We would like to thank both Reviewers for their constructive suggestions on how to improve the manuscript. In the following, we provide answers to comments from Referees below.

To anonymous Referee #1, 23 May 2022

- 5 This manuscript is about the temporal downscaling of satellite based terrestrial water storage anomalies (TWSA) using data-based methods with in-situ meteorological data and assimilated soil moisture data as inputs. In addition, a new index is proposed incorporating downscaled TWSA estimates and daily precipitation to monitor flood events. The concepts are applied to four (sub-)basins of the Yangtze River Basin (YRB) in China.

Figure 1: Location of the Yangtze River Basin (YRB) in China and its topography. Distribution of meteorological stations and hydrological stations are also shown in this figure. TGR = Three Gorges Reservoir; DEM = Digital Elevation Model.

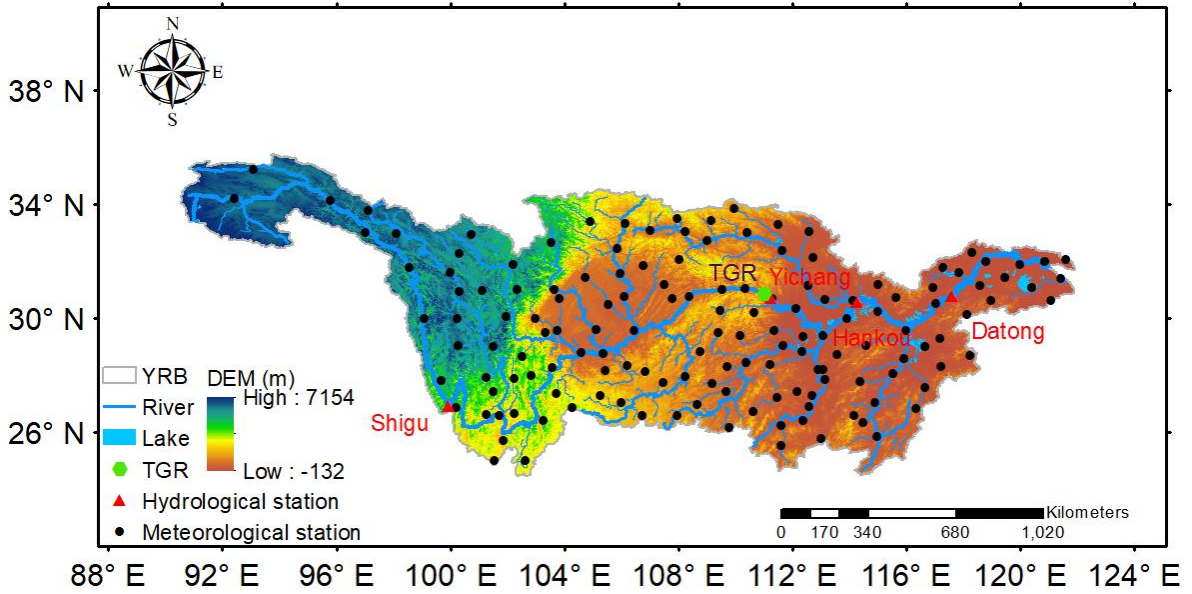
L768: The Three Gorges Reservoir is difficult to identify on the map.

980 Response: To make it easy to identify on the map, we have changed the symbol and color of the Three Gorges Reservoir as shown in Figure 1 (denoted as a green hexagon).

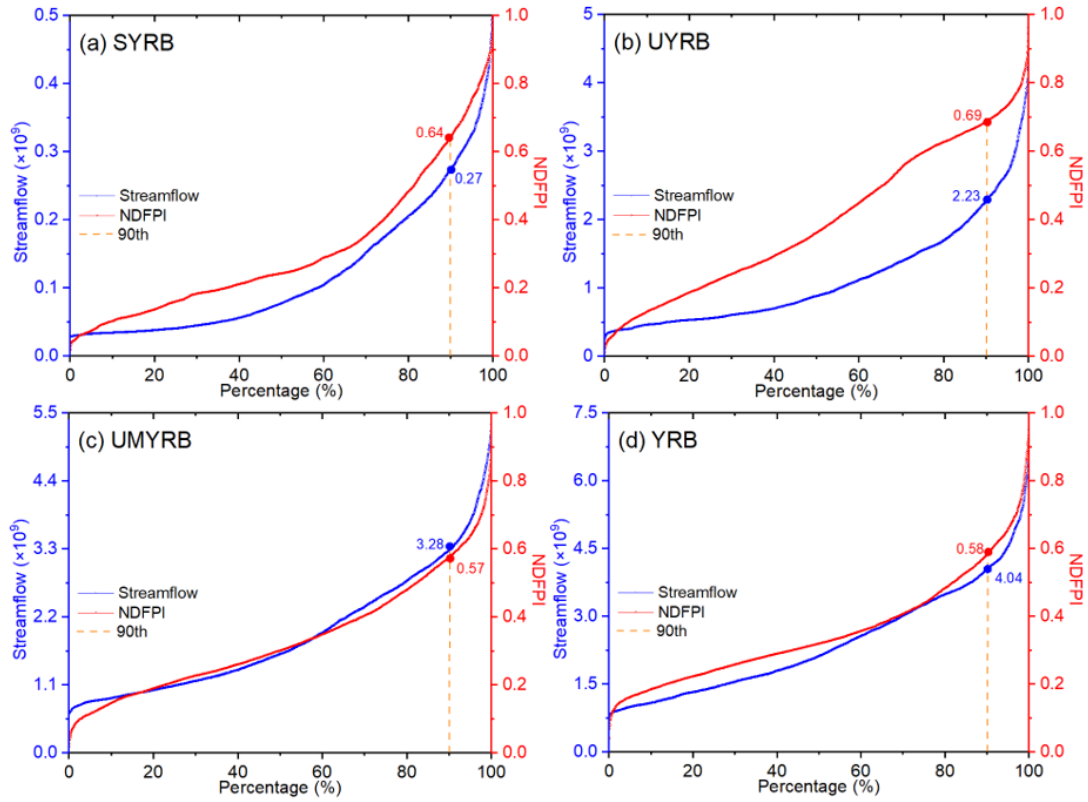
(7) Figure 9 and Figure 10: Please add the meaning of acronyms, such as NDFPI in the captions of these figures.

1090 Response: As described in Figure 9 and Figure 10, we have added the meaning of these acronyms in the captions of these figures based on your suggestions.
